ALIGNMENT FOR THE OUTER METROPOLITAN RING / E6 TRANSPORT CORRIDOR

PROPOSED MAJOR CORRIDOR CHANGES

Reasons for not changing the proposed Outer Metropolitan Ring / E6 Transport Corridor alignment
(Strategic Issues - Refer to Map 8)

MAP 8: SUGGESTED ALTERNATIVE CORRIDOR OPTIONS TO DISPLAYED OUTER METROPOLITAN RING/E6 TRANSPORT CORRIDOR ALIGNMENT

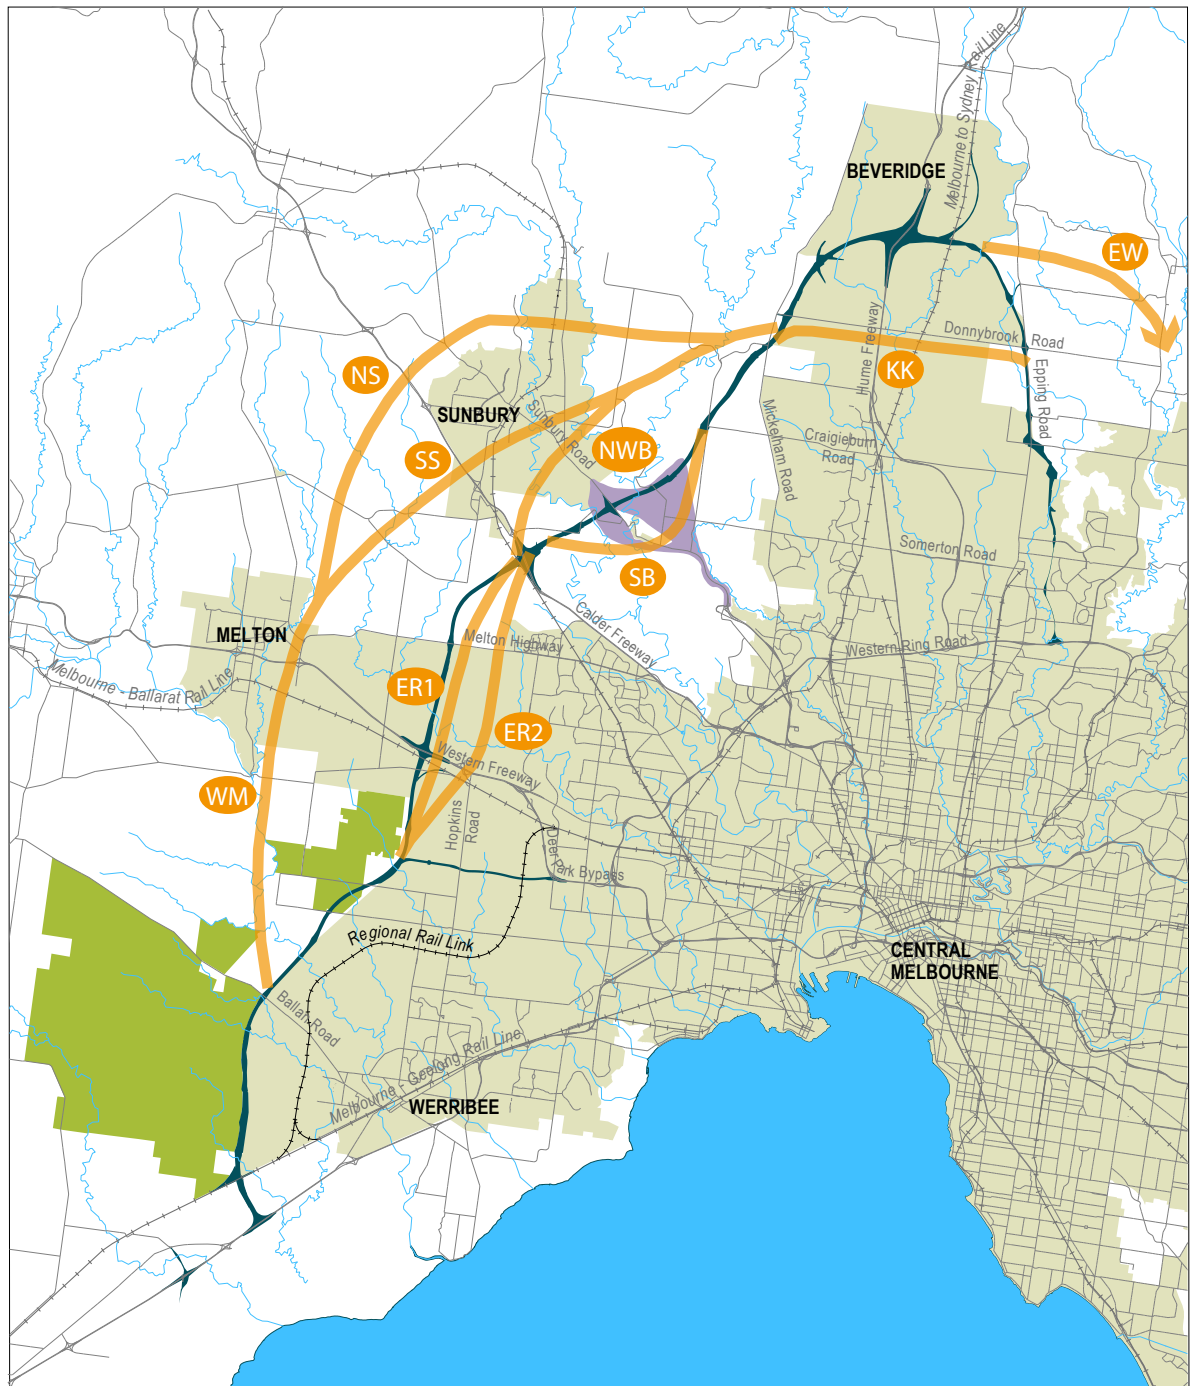
Map Ref	Location	Change Proposed	Explanation why proposed change is not accepted
8ER1/ ER2, 8-NS/ WM, 8-KK	Rockbank, Diggers Rest, Mickleham	A number of submitters sought corridors that were discussed and rejected in the Outer Metropolitan Ring /E6 Transport Corridor Planning Assessment Report	The reasons for recommending the displayed corridor were set out in the Planning Assessment report. No new evidence was presented in submissions that justified a change of corridor.
8-SB	Diggers Rest	Some submitters proposed an option to the south of Diggers Rest that would require passing to the south of Bulla.	<p>A corridor option further to the south would either impact on Organ Pipes National Park or pass to the north of Organ Pipes National Park and require multiple crossings of Jacksons Creek.</p> <p>This proposed corridor option would not provide as a direct a connection for the Outer Metropolitan Ring/E6 Transport Corridor, it would result in a longer route and due to the bridges required, would have considerably higher construction costs and/or would have unacceptable impacts on the Organ Pipes National Park.</p>

8-EW	Epping / Woodstock / Wollert	<p>A number of submissions sought that the E6 should only be constructed as an arterial road and only as far north as Bridge Inn Road.</p> <p>A number of submissions indicated that the existing arterial road network should be upgraded in preference to constructing the E6 as a freeway.</p>	<p>It is accepted and agreed that preference should be given to upgrading the existing arterial road network before constructing a new freeway in a new alignment corridor. It is likely that the E6 would be constructed as an arterial in the first stage.</p> <p>High level strategic transport modelling clearly indicates that, ultimately, north-south travel demand in the corridor will be of such a level as to require the construction of a six lane freeway in the E6 corridor, even with widening of the Hume Freeway to four lanes in each direction.</p> <p>Hence, it is considered prudent planning to enable a future government to have the ability to determine whether to construct a freeway within the E6 reservation. Previous experience has shown that it is very costly and disruptive to seek to upgrade an arterial to a freeway at a later date if this requirement has not been allowed for and incompatible development has occurred adjacent to a road corridor.</p>

8-EW	Epping / Woodstock / Wollert	Several submissions sought an alignment for the E6 further to the east to create what the submitters consider would be a more complete ring road of outer Melbourne. Such a corridor would need to connect the Outer Metropolitan Ring / E6 Transport Corridor to the Eastern Freeway / EastLink through Warrandyte and Eltham, or Lilydale.	<p>The environmental and social impacts of this option would be expected to be major, and would be larger than the environmental and social impacts of the recommended option, as there is not a reserved corridor for such a proposal through any areas of low environmental values. Such a corridor, as suggested, would serve a less populated area, with consequent lesser usage and would therefore have fewer transport user benefits than the recommended option.</p> <p>For longer distance travel, the recommended option would make use of existing corridors such as the Metropolitan Ring Road and the Eastern Freeway/EastLink, thereby maximising the use of investment in existing corridors.</p>

MAP 9: SUGGESTED CHANGES TO DISPLAYED OUTER METROPOLITAN RING/E6 TRANSPORT CORRIDOR ALIGNMENT

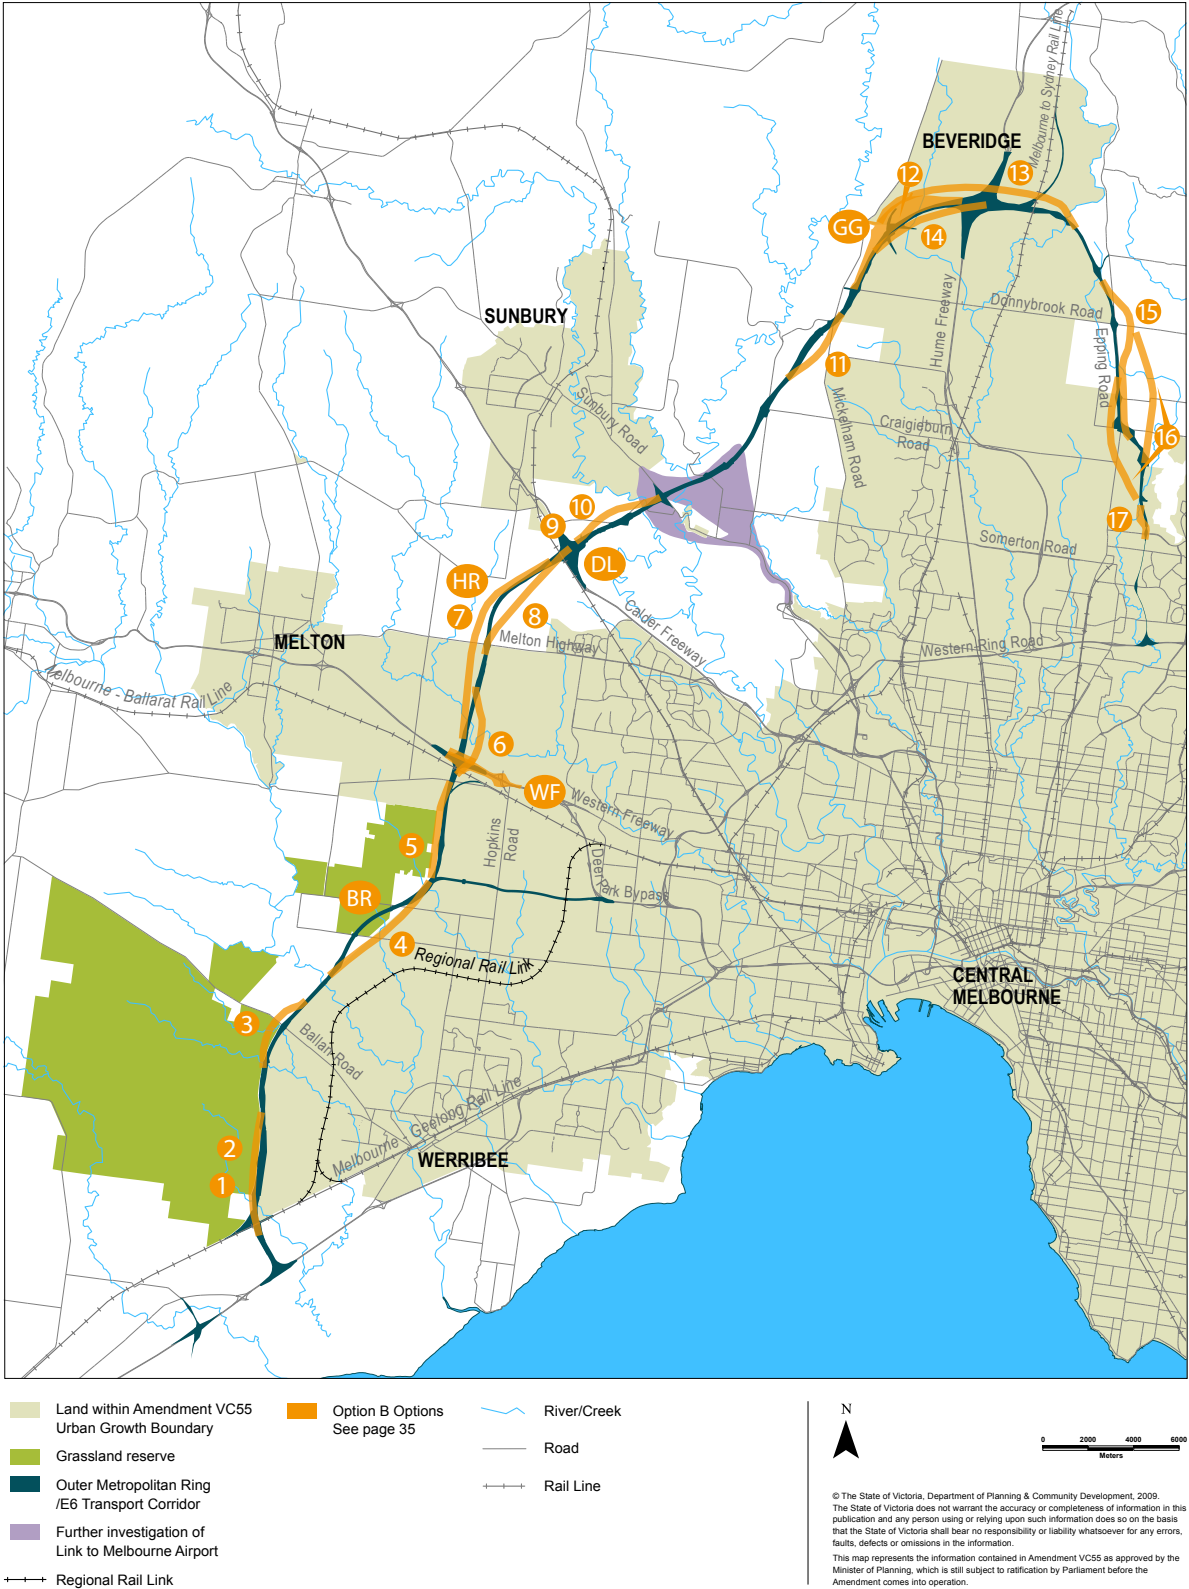
Map Ref	Location	Change Proposed	Explanation why proposed change is not accepted
9-2 / 9-3	Wyndham Vale (Black Forest Road to Ballan Road)	A number of submitters suggested a westward shift of the OMR/E6 alignment	Such a shift would be expected to result in the Outer Metropolitan Ring / E6 Transport Corridor impacting on the proposed grassland reserve.
9-5	Rockbank (Middle Road to Western Highway)	Submitters sought that the OMR/E6 alignment be shifted either west of Troups Road, or at least further west on their properties, just to the east of Troups Road.	An alignment west of Troups Road is not acceptable as it would impact on the proposed grassland reserve. It was not considered feasible to shift the OMR/E6 alignment further west as it would also be located further west on the northern side of the Western Highway. This would impact adversely on proposed urban development to the west. An alternative alignment would also result in three extra homes/buildings needing to be acquired from other properties.

9-6	Rockbank – Greigs Road to Tarletons Road (part)	Locate the OMR/E6 up to 870m further to the east (Option B) of the originally displayed alignment (Option A)	Option B is considered to have a poorer land use outcome than the originally displayed Option A. It would reduce the area available for urban development east of the OMR/E6. It would leave less area for high quality development adjacent to Kororoit Creek. The area to the west of the OMR/E6 with the original Option A would still be a large viable development area. The impact of the original Option A on the Deanside Wetland is not considered to be so significant as to require relocation of the OMR/E6. Option B would impact an additional 8 houses/buildings (30 compared with 22) and would be 300m longer (6.6 km compared with 6.3 km). Option B would also impact on other wetlands and leave some properties trapped between a new subdivision and the Creek.

9-7	Rockbank - near Tarleton Road	A submission suggested a westward shift of the OMR to avoid a flood prone area and to reduce the impact on houses.	The proposed transport corridor does not need to be moved to avoid the flood prone area because the transport corridor can cross this area using a bridge, pipes or culverts.
9-8	Plumpton (Melton Highway to Calder Freeway)	Submitters in the vicinity of Holden Road/Plumpton Road sought an alignment shift further to the east to avoid homes and to place the alignment further into the Airport Environs Overlay area.	The alignment of the OMR/E6 transport corridor south of the Melton Highway has been selected to minimise impacts on future development. The alignment of the OMR/E6 Transport Corridor in the vicinity of the Calder Freeway has been selected to minimise impacts on Calder Park and Diggers Rest. It is important for the OMR/E6 Transport Corridor to cross the Melton Highway at a right angle to facilitate development south of the Melton Highway.

Map Ref	Location	Change Proposed	Explanation why proposed change is not accepted
9-9	Diggers Rest – Bulla-Diggers Rest Road Interchange	Submitters sought to maintain the interchange of Bulla-Diggers Rest Road with the Calder Freeway.	<p>The current Calder Freeway/Bulla-Diggers Rest Road interchange is located too close to the proposed Outer Metropolitan Ring / Calder freeway interchange to enable safe operation of both without costly ramp braiding or other treatment works.</p> <p>Alternative access to the area to the north is available via the existing Calder Freeway/Vineyard Road interchange. Additionally, there is planning underway for a new interchange on the Calder Freeway at Calder Park Drive. This interchange will incorporate access to Duncans Lane to the south via Thompsons Road, thus providing access to the area to the east of the Calder Freeway at Diggers Rest.</p> <p>Consultation is required to determine the need for any further complementary work to upgrade the local road network to be undertaken to maintain a similar standard of road access to the area to that which currently exists (eg bridge strengthening to maintain access for heavy vehicles).</p>

9-10 / 9 DL	Diggers Rest	Submitters sought relatively minor shifts of the OMR/E6 to reduce the impact on their properties.	<p>The location of the OMR/E6 Transport Corridor is limited by the need to achieve satisfactory crossing locations of Jacksons Creek and Deep Creek and by the need for a satisfactory interchange location with the Calder Freeway. Hence, it is not feasible to realign the OMR/E6 Transport Corridor through this area.</p> <p>However, further investigation of the OMR/E6 Transport Corridor revealed that it is possible to amend the proposed right of way slightly to minimise property acquisition and access impacts in the vicinity of Duncans Lane. Key changes include realigning of Duncans Lane and reducing the OMR/E6 land requirement in the vicinity of the Calder Freeway/OMR/E6 interchange.</p>
9-11	Mickleham / Konagaderra Springs	Submitters in the vicinity of Mickleham sought an alignment shift to the east to avoid properties in the Bardwell Drive/ Parkland Crescent area.	Option 1e considered in the Planning Assessment Report was located east of Mickleham Road in this area. This option was ruled out because of its impacts on areas of biodiversity significance and cultural heritage in the Mickleham / Mount Ridley area, including the 'Avenue of Honour' located on Mickleham Road.

9-12	Mickleham - Donnybrook Road to Hume Freeway and east of Merri Creek	<p>Locate the OMR/E6 Transport Corridor further to the north/west (Option B) of the originally displayed alignment (Option A).</p> <p>Enable the provision of an additional interchange to serve adjoining land on the Hume Freeway north of Donnybrook Road.</p>	<p>Option B would reduce the catchment area for the activity centre north of the OMR/E6 relatively close to where that centre would be located while not substantially increasing the primary catchment area for the Merrifield activity centre, as access to that centre and development would be constrained by the flood retention basin.</p> <p>Option B would have greater potential for adverse landscape implications on the hills on the western side of the valley. It would also impact more significantly on properties on the east side of Mickleham Road severing houses from dams and other agricultural infrastructure.</p> <p>An additional interchange to serve the adjoining land could be located within the OMR/E6 Hume Freeway interchange area, if required. This will need to be considered further in the Growth Area Framework Planning process.</p>

Map Ref	Location	Change Proposed	Explanation why proposed change is not accepted
7-14	Mickleham - Donnybrook Road to Hume Freeway]	A submitter sought that the OMR/E6 alignment be moved south to lessen the impact on the Alma Vale property.	A southward shift of the alignment would potentially increase the adverse impact on the Melbourne Water retarding basin. While it would increase the developable land on the north, this would be offset by a decrease in the area of developable land on the south side, with little net effect.
7-16	Wollert – Bridge Inn Road	A submitter sought a significant alignment shift to avoid the proposed quarry near the south-east corner of Epping Road and Bridge Inn Road, Wollert.	<p>It is not possible to design an alignment that would pass to the west of the proposed quarry property, and also avoid an area of land, to be developed for housing which is within the existing Urban Growth Boundary and has an approved structure plan. Alignments which avoid proposed quarry land on the southeast corner of Epping Road and Bridge Inn Road would pass through quarry land north of Bridge Inn Road.</p> <p>In order to avoid property on the west side of Epping Road, the impact on quarry land of the revised Option B would instead be greater.</p>
